Highways England Planning Response (HEPR 16-01)

Formal Recommendation to an Application for Planning Permission

Council's Reference: LCC/2021/0007

Referring to the notification of a planning consultation dated 16th February 2021 for the prior extraction of sand / gravel and subsequent restoration with inert engineering fill to facilitate a platform for employment development or agriculture with peripheral landscaping on land north of the A674 Millennium Way, north east of M61 Junction 8 at Chorley, Highways England's formal recommendation is that we:

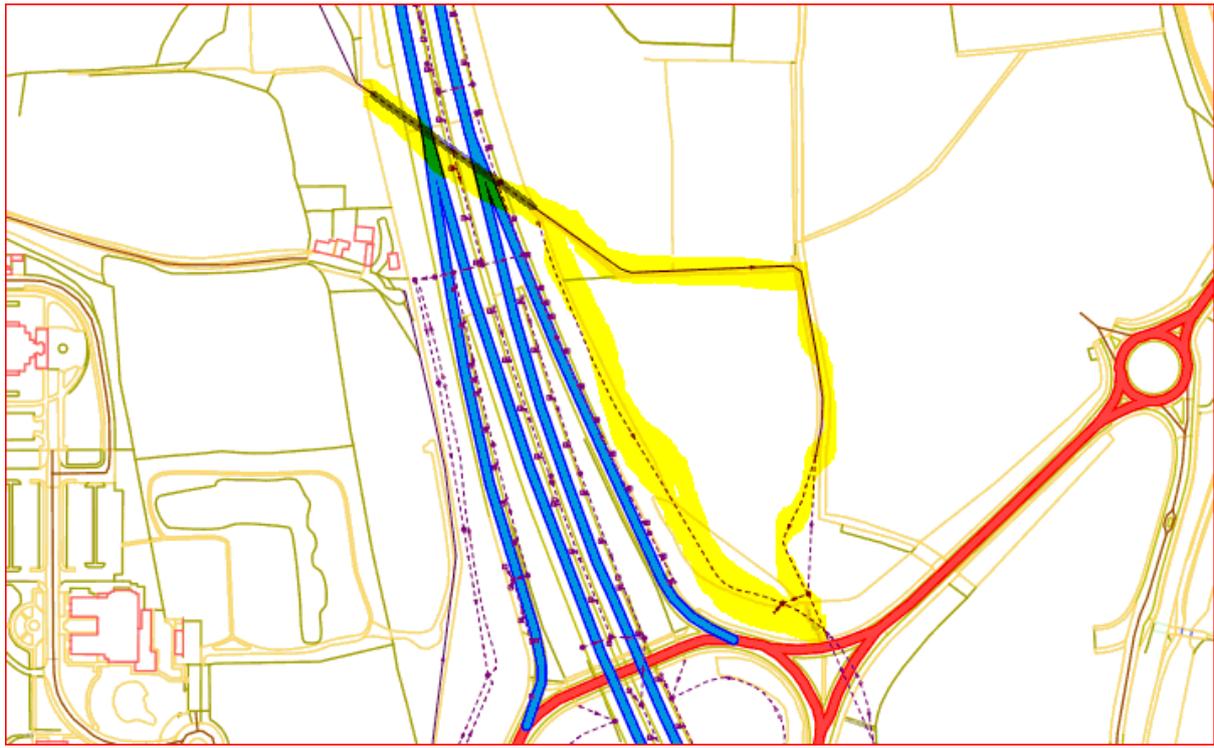
A motorway filter drain runs along the motorway boundary with this site at the foot of the motorway embankment., as shown in the drawing below. **Again, there will need to be a level of standoff agreed with Highways England from the excavation to ensure that this drain is not disturbed.**
